American Champion Aircraft Corp.
Rochester, WI 53167

Service Letter: 430, Revision A

Title: Conversion of 7ECA, 7GCAA and 7GCBC to Lycoming O-320-B2B or Equivalently Provisioned Engine per TCDS E-274.

Figure 1, Firewall Modifications

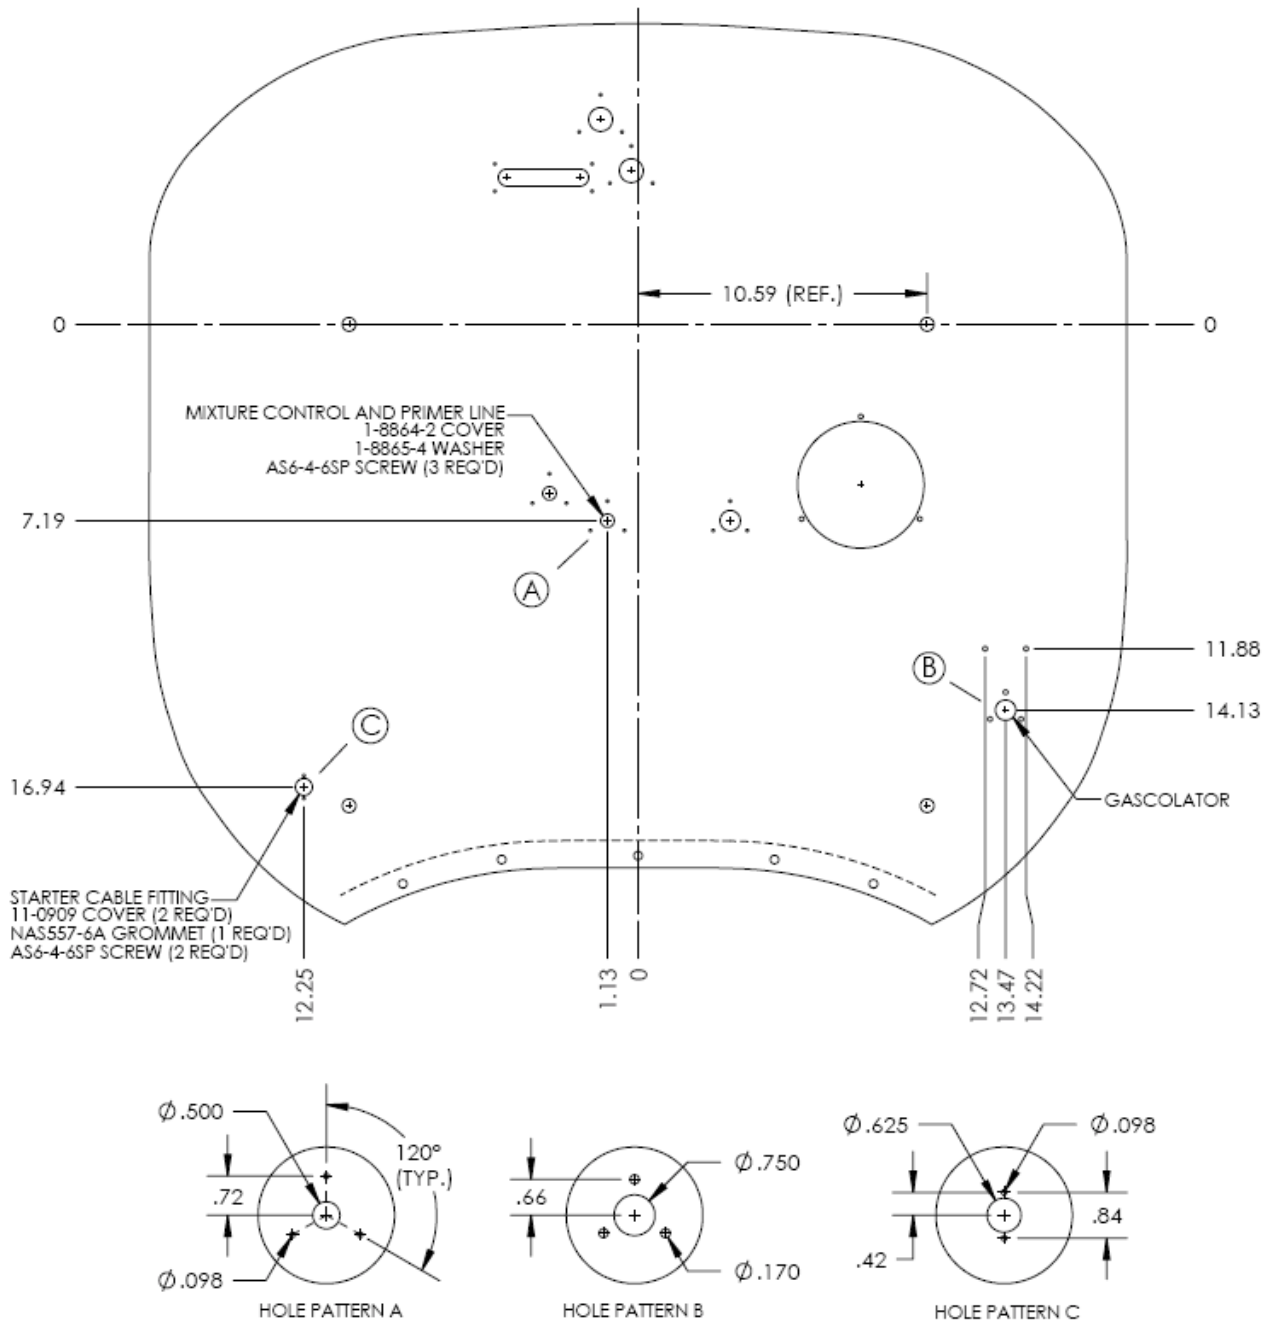
Replace and relocate gascolator. See figure 1 for correct placement of the new gascolator. Replace carburetor fuel line with Aeroquip hose 624000-8D-0154. Replace fuel valve bracket with 11-0831 per ACAC drawing 7-1290. Components from the gascolator to and including the fuel manifold must also be replaced; install components per ACAC drawing 7-1476.

The existing 4-1640 firewall must be modified with the addition of the three hole patterns shown in figure 1, or replaced with a new 4-1640-4 firewall. Plug any unused holes with 1-8864-6 cover, 1-8865-4 silicone washer and AS6-4-6SP screws.
